Response to RC3: 'Comment on acp-2022-668', Anonymous Referee #3, 31 Mar 2023

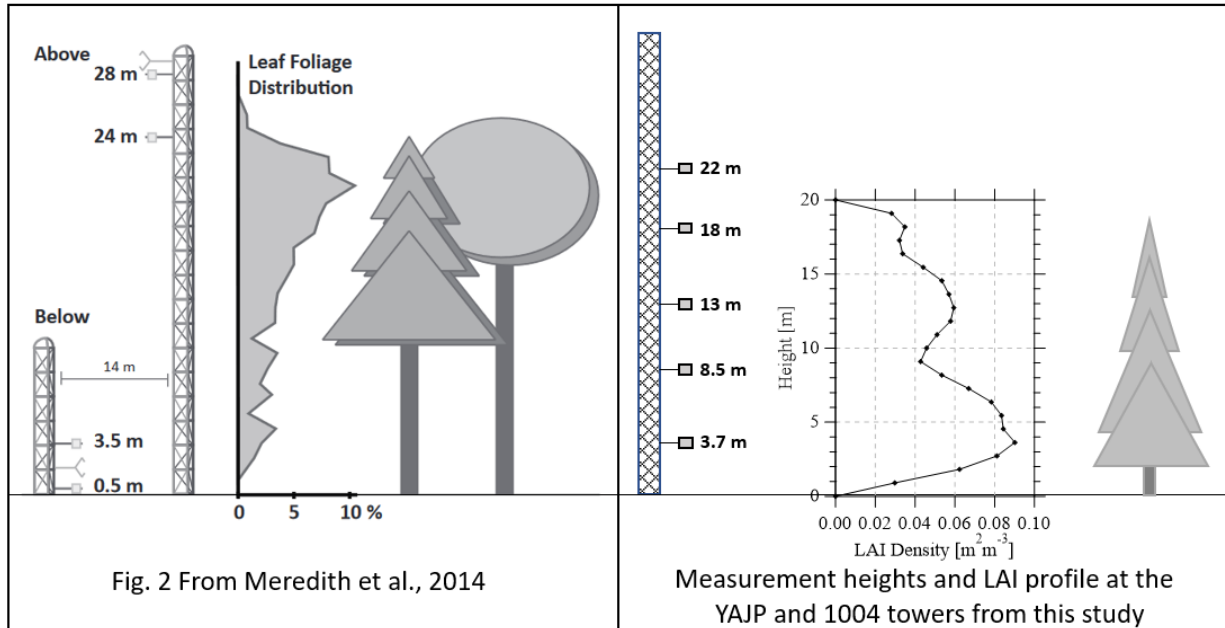
1. As pointed out by reviewer 2, the flux/gradient method generally requires that there be no source or sink within the region over which the gradient is estimated. As a result, the gradient is generally measured well above the canopy (see for instance Meredith, et al. (10.5194/amt-7-2787-2014) and references therein). In this study, the gradients are calculated using observations collected above and below the canopy (Fig. 2). This implications of this setup on the derivation of $v_d(\text{SO}_2)$ need to be addressed very carefully given the body of literature that argues against it.

AC3.3: We have revised the paper to address this important issue. Text is added to Sections 2.2, 2.4, 3.3, 4.1, and the Conclusions. The LAI density profile is added to Figure 1 to demonstrate

the vertical distribution of the leaves at this site. A column is added to Table 1 in which the deposition velocity is calculated with the 2 above-canopy measurement heights. The figure below (not included in the revised manuscript) compares the LAI profile for our study with the LAI profile of the Harvard Forest where the Meredith et al. (2014) study was done. Although we define the canopy height in our study as 19 m based on the highest vertical extent of the trees, Meredith et al. (2014) define the canopy height based on the mean leaf-foliage value (giving a height of 18 m for that forest). Defining the canopy height in this way for the boreal forest in our study would give a height of ~11 m, demonstrating that our 2 highest measurements can also be considered well above the canopy.

This figure (not included in the revised manuscript) compares the above-canopy measurement locations and LAI from Meredith et al. (2014) with the measurement heights and LAI from this study, demonstrating that the two highest measurement heights can be considered “above-canopy” relative to the forest leaf distribution.
